## **EARLY DESIGN GUIDANCE MEETING #2**

DPD# 3016702 April 7, 2015

**2ND + STEWART**

1613 2nd Avenue, Seattle, WA 98101

**EDG #1 RETAIL / STREET LEVEL USES**

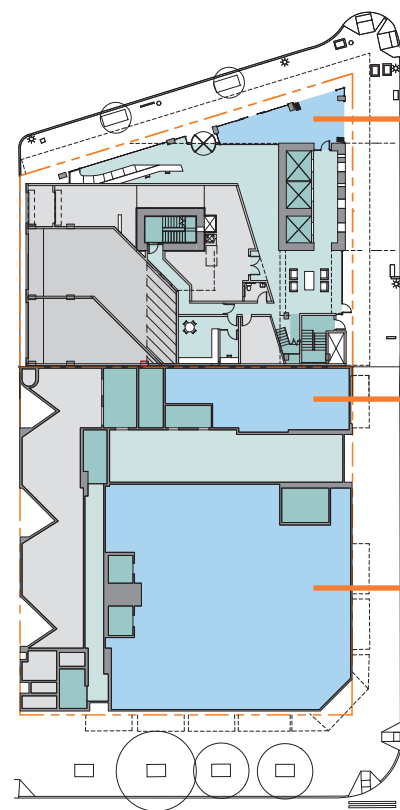
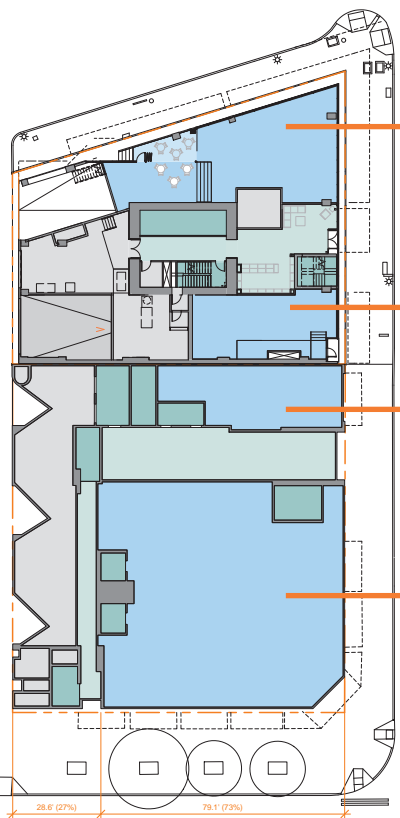
"The Board members were in agreement that there was insufficient retail presence proposed at street level in the new structure. One Board member noted that "Alternative 1" was more successful in that regard than was the preferred Alternative 3. The Board members were unanimous in indicating their disapproval of a departure request for less than the Code-required amount of retail space. It was suggested that the design team look into alternatives for locating residential lobby functions to a floor above the ground floor level to accommodate increased retail."

Response:

- Street level Use Departure no longer requested.
- All non essential residential uses relocated to floors above the street level.
- Proposed retail SF area increased from 500 sf to 2,613 sf. (total development site retail area including Broadacres Building 9,059 sf)

**EDG #1 - CORE ON 2ND AVE**

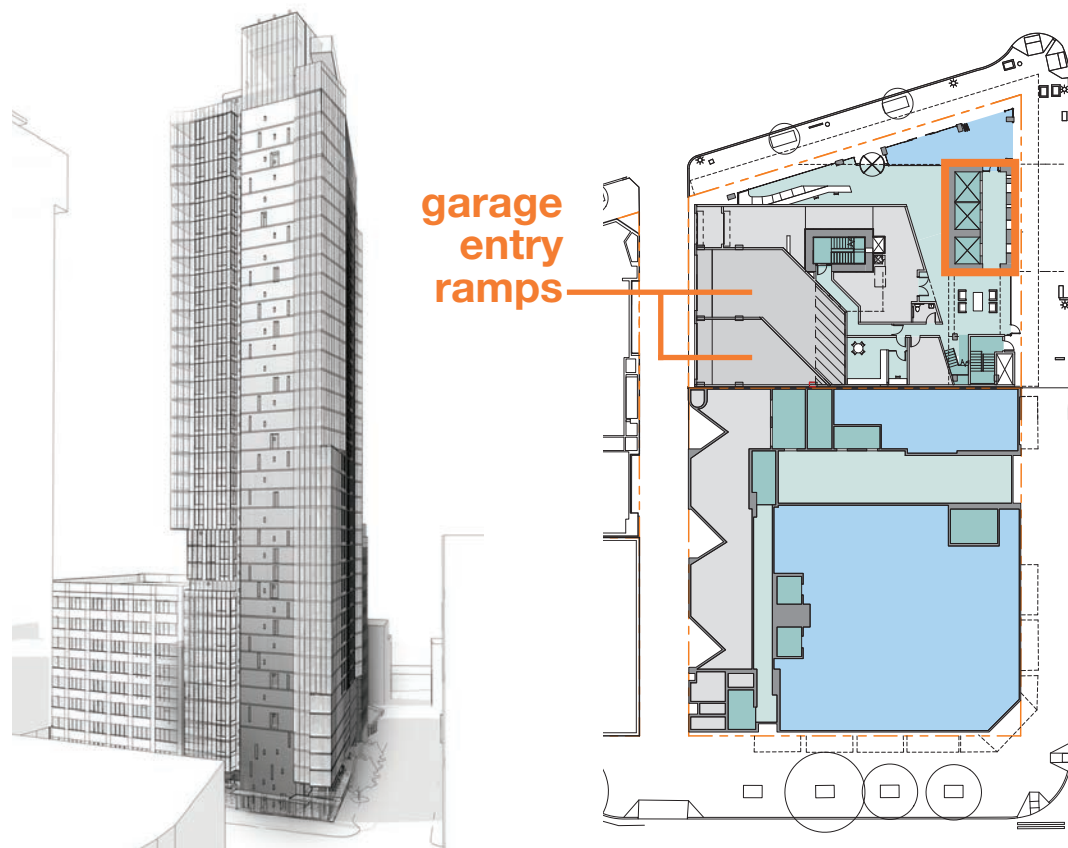
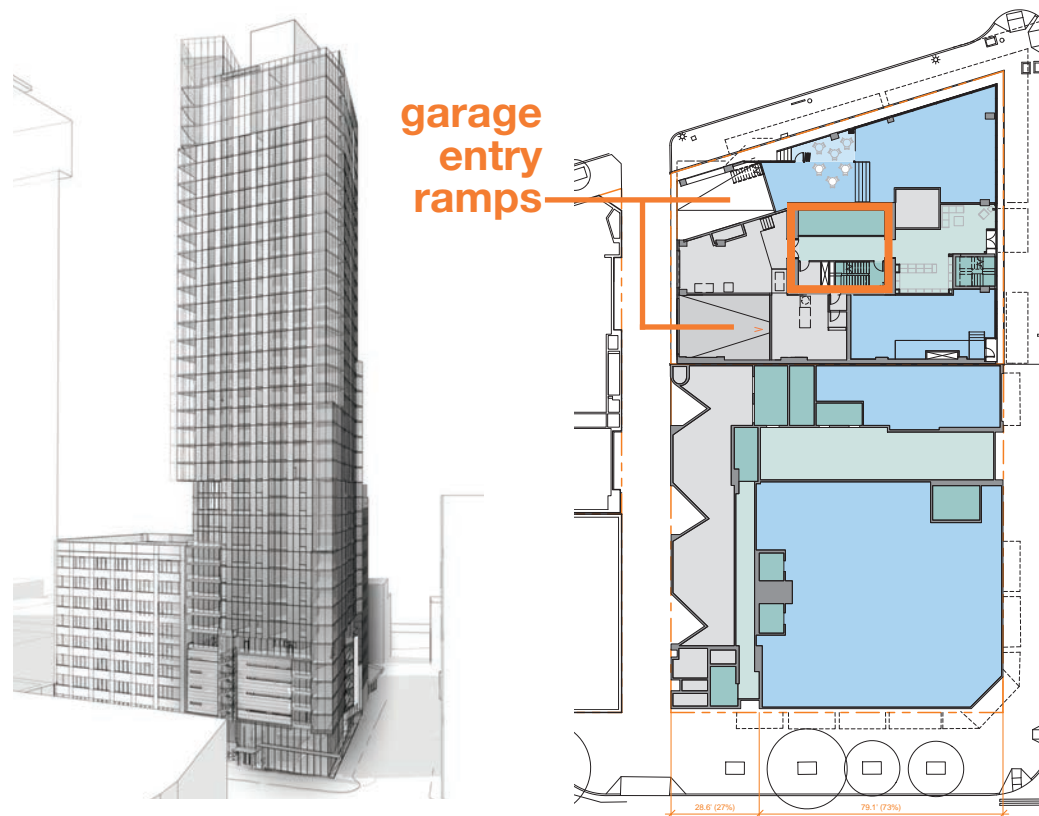
*The Board members also reacted negatively to the expressed/ exposed structural core at the perimeter of the building on 2nd Avenue. The inevitable "blank" expression at the façade as well as the core's ability to gobble up space that could be given to retail uses at the street level made the feature and the move less than welcomed.*

**Response:**

- Street level Use Departure no longer requested.
- All non essential residential uses relocated to floors above the street level.
- Proposed retail SF area increased from 500 sf to 2,613 sf. (total development site retail area including Broadacres Building 9,059 sf)
- North garage entry ramps adjacent to Stewart Street but within the allowed 25% of Street Level Use frontage for vehicular and pedestrian access.
- Similar separation of uses for above grade parking at Second Ave. and Stewart maintained from EDG #1 preferred alternative.

**EDG #1 - ABOVE GRADE PARKING**

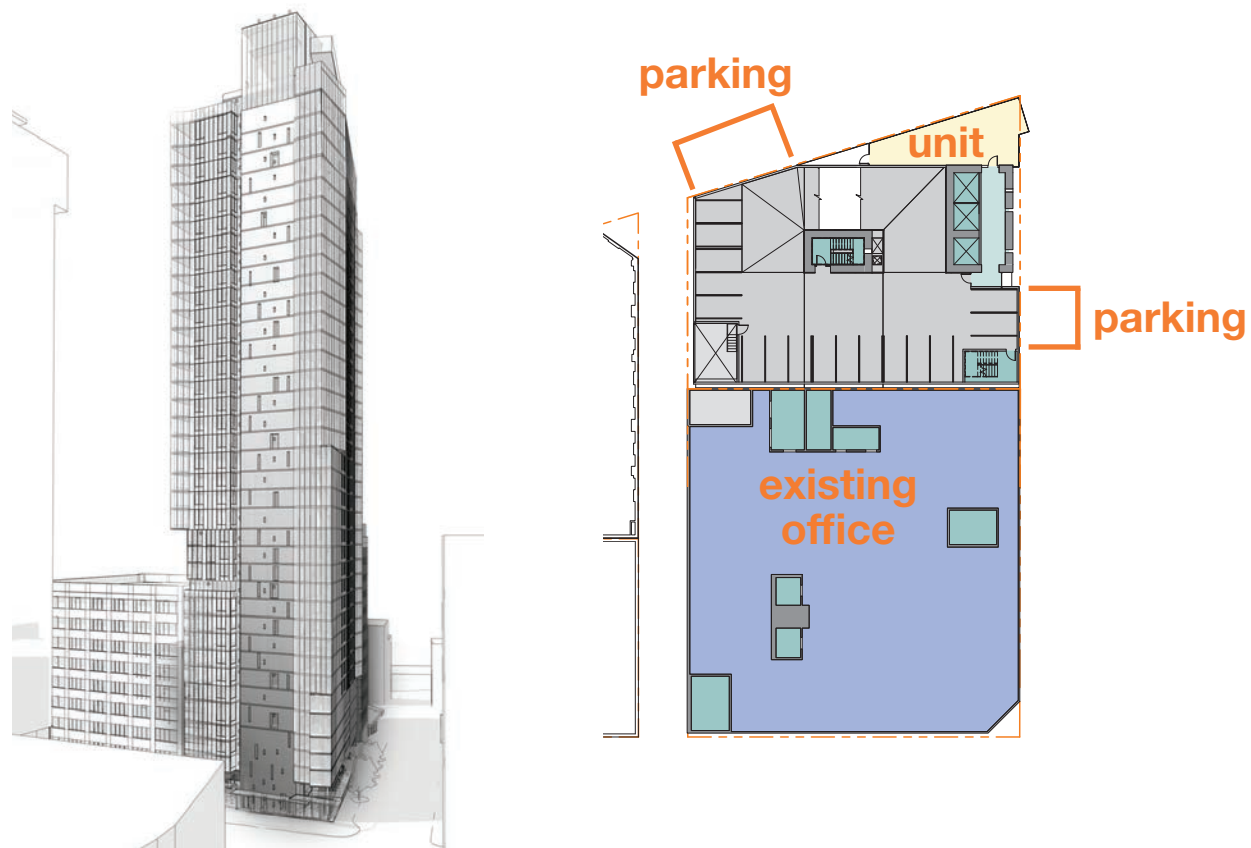
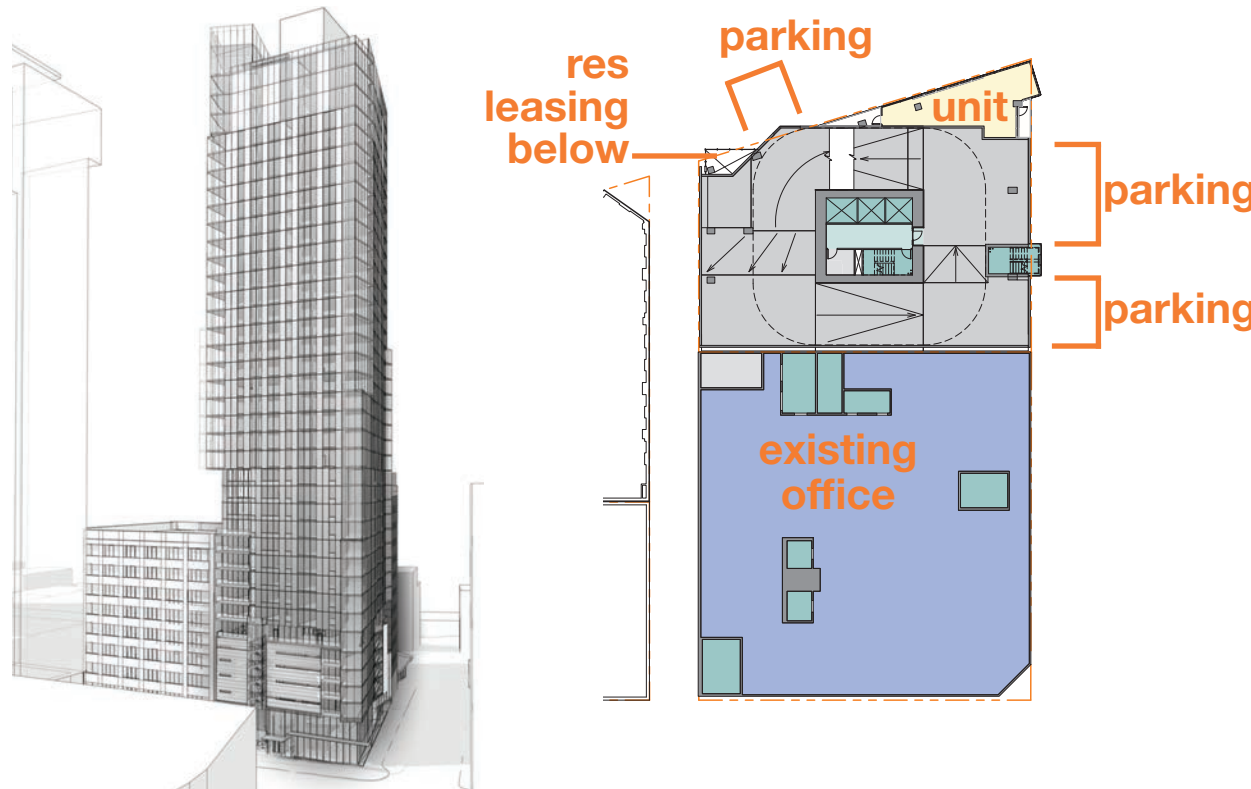
The Board was displeased how the above-grade parking seemed to be driving the building's functionality and appearance, noting that they were unaware of an instance in the City where copious amounts of above-grade parking did not substantially compromise a well-integrated design or mar the aesthetic qualities of an otherwise attractive building. There was clearly a challenge for the prospect of a successful outcome in this instance.

Finally, it was suggested by members of the Board that the above-grade parking, if adroitly handled, could perhaps be received with a less critical eye if the issues of the peripheral core and quantity of retail space had been judiciously addressed.

Response: Second Ave core relocated to the center of the floor plate reconfigures the vehicle circulation. This increased the amount of facade area needing to screen parking in the EDG #2 alternatives. (However, the relocation of the core above the parking levels are now residential units and provides more street level retail uses.) This increase is addressed through an interaction between massing of building elements. A direct expression of the ramp slope provides visual interest. Residential balconies on both streets weave the parking facades together with the residential uses on the same level. On Second Ave., balconies and horizontal slots in portions of the facade screening parking relate to the facade pattern of the Broadacres building.
